**ADDENDUM TO BID
FIRE STATION 11 ROOF REPLACEMENT
BID: 612-F-073
ADDENDUM NO.: 2**

RMER WALL PANEL
SECTION

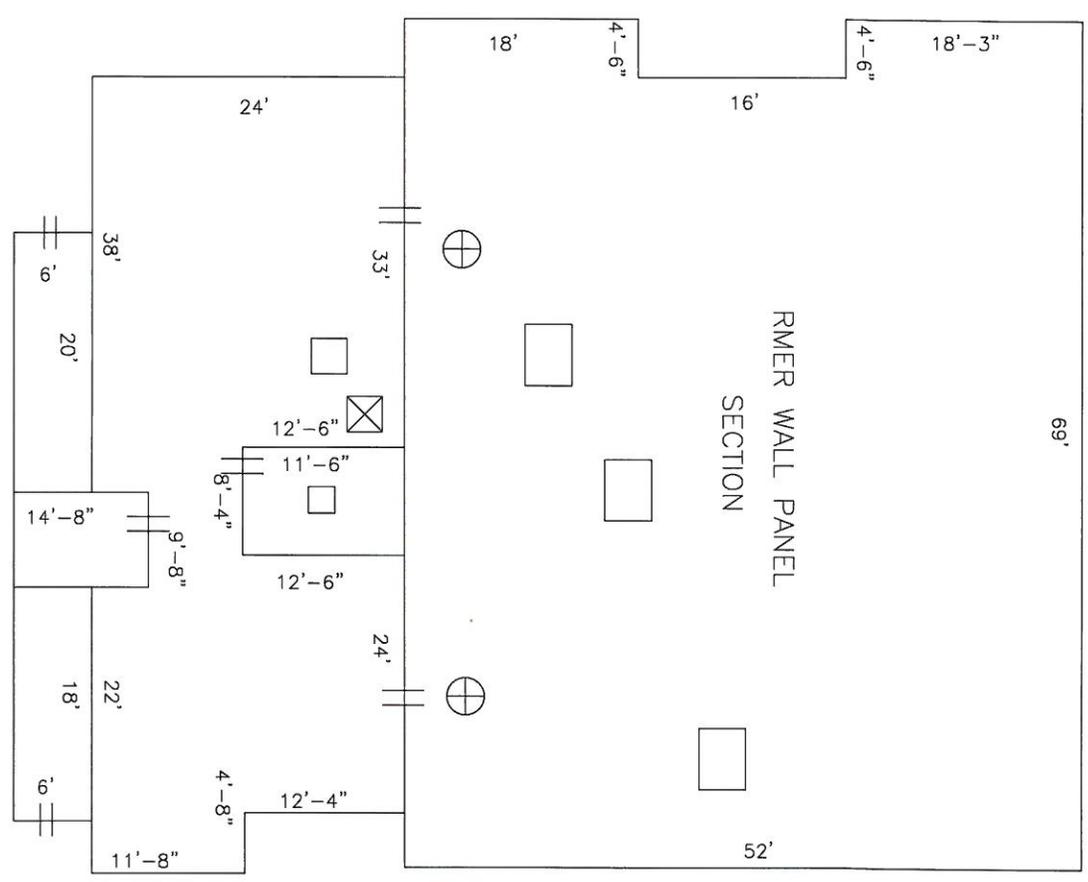
- Contractor to furnish, fabricate, and install sheet metal around existing scuppers
- Site specific wall panel dimensions will be 12 -3/4" W x 32" H
- Any material needed which is not listed on the Garland product material list is the responsibility of the contractor and should be included in the base bid

- Contractor to furnish hat channels and fasteners necessary for wall panel assembly
 - Clips necessary for wall panel assembly can be found on Garland Material List

- **Pyramic** – Reflective coating used on all exposed flashings and similar work, see specification for more information.
 - **RMER Wall Panel** – Metal wall panels used for north section parapet wall (noted on facility drawing), see specification for more information

R-MER LINE WALL PANEL

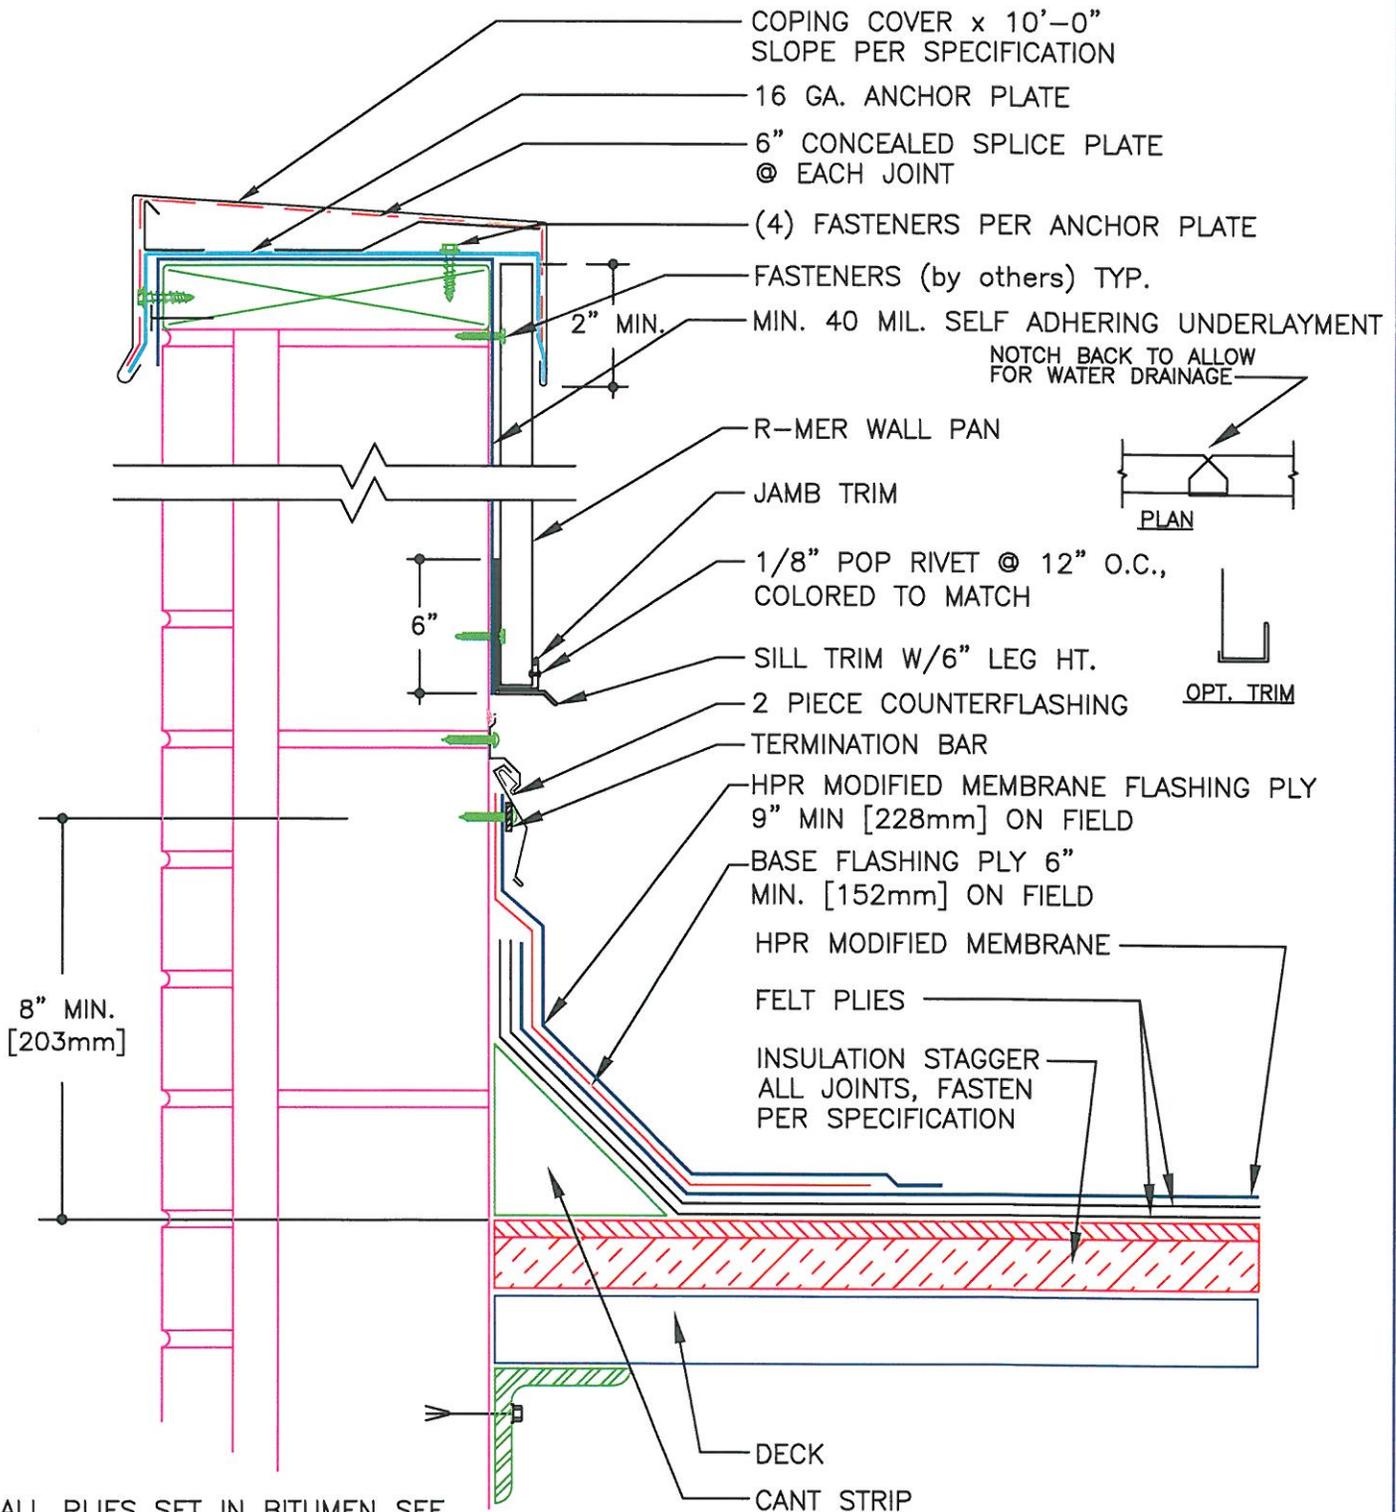
- Contractor to furnish metal necessary for counter flashing
- Contractor to furnish and install 40 mil (min.) self-adhering underlayment to areas receiving the new metal coping and new metal wall panels.
